PLANNING & ZONING AGENDA ITEM #8

SUBJECT: Approval of a Final Plat for Timberline School Plat I

RE: Timberline School – Site Plan/Preliminary Plat & Final Plat

WAUKEE TIMBERLINE SCHOOL PLAT 1

FINAL PLAT

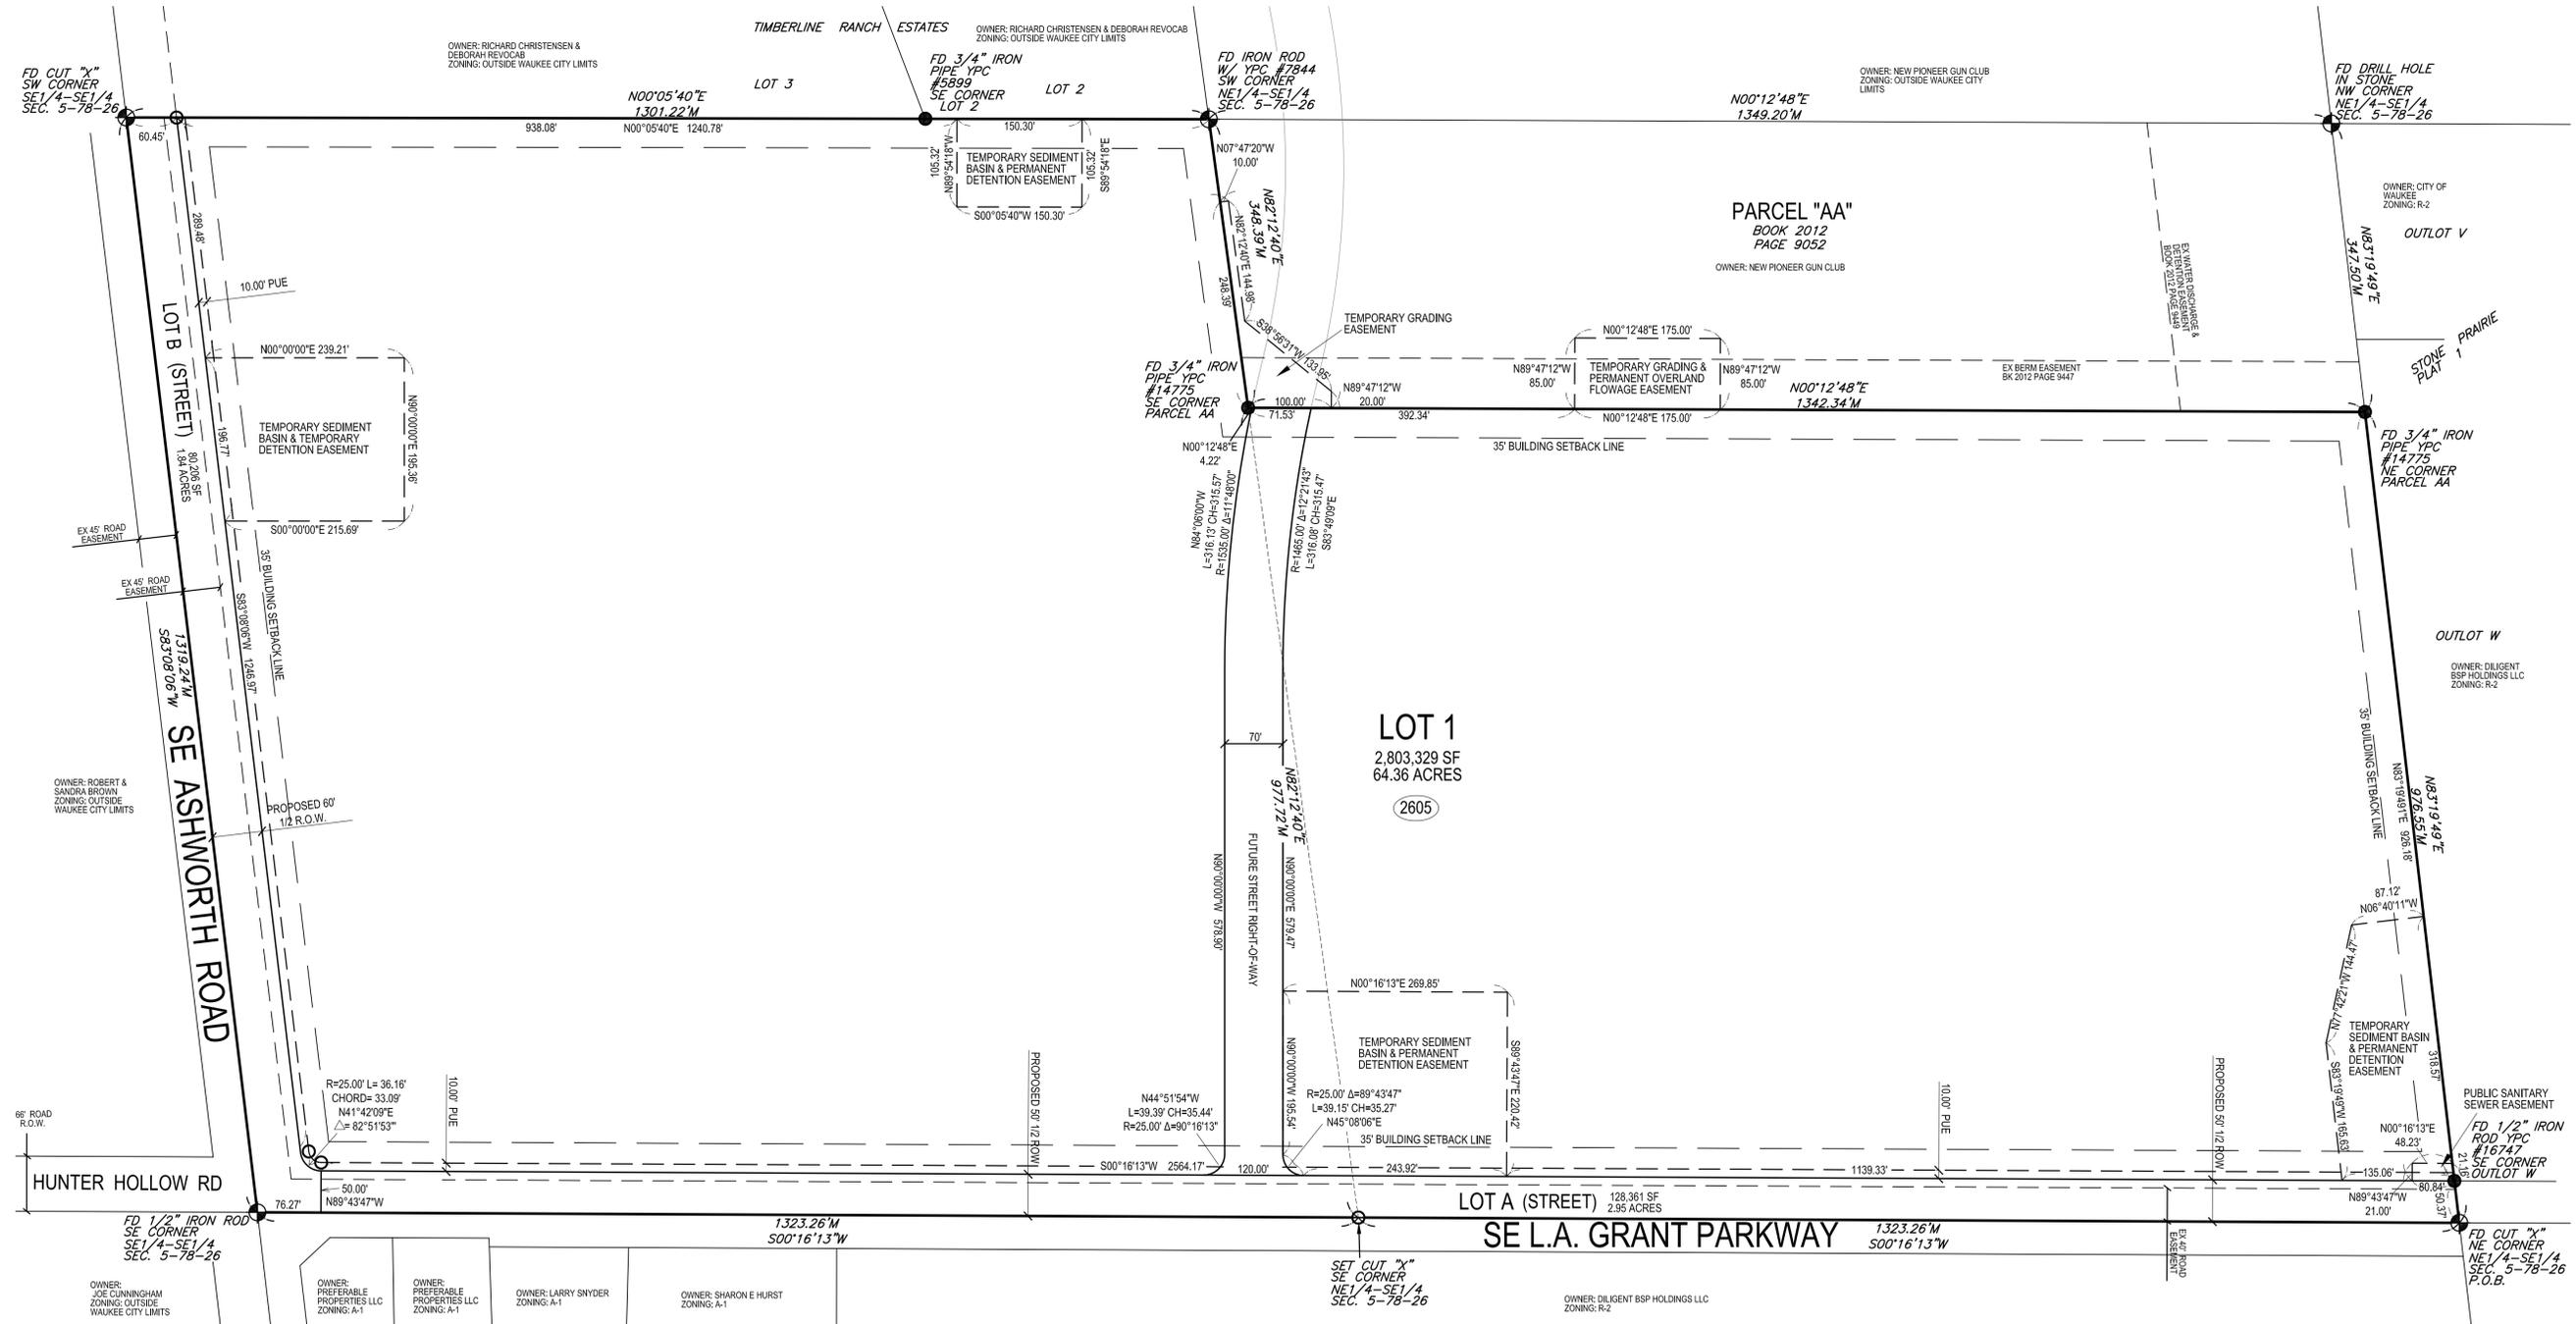
86. The legal description should be provided in metes and bounds.
87. **All existing and proposed easements should be indicated on the final plat including any off-site easements.**

88. LA Grant Parkway should be revised and labeled as SE L.A. Grant Parkway. Additionally, Ashworth Road should be revised and labeled as SE Ashworth Road.

89. The location of Hunter Hollow Road on the south side of SE Ashworth Road should be indicated on the final plat for clarity. Additionally, the property ownerships and lot line locations on the south side of SE Ashworth Road near the intersection with SE L.A. Grant Parkway should be indicated on the final plat.

90. A 10 foot public utility easement should be provided adjacent to both SE L.A. Grant Parkway and SE Ashworth Road.
91. Separate street lots should be provided for the SE L.A. Grant Parkway and SE Ashworth Road right-of-ways. Additionally, the radius at the intersection should be dedicated as a part of this plat.

92. **All legal documents associated with the plat should be provided for review prior to City Council consideration.**

**93. Staff would request that the future east/west street ROW be indicated on the final plat.
Please address.**
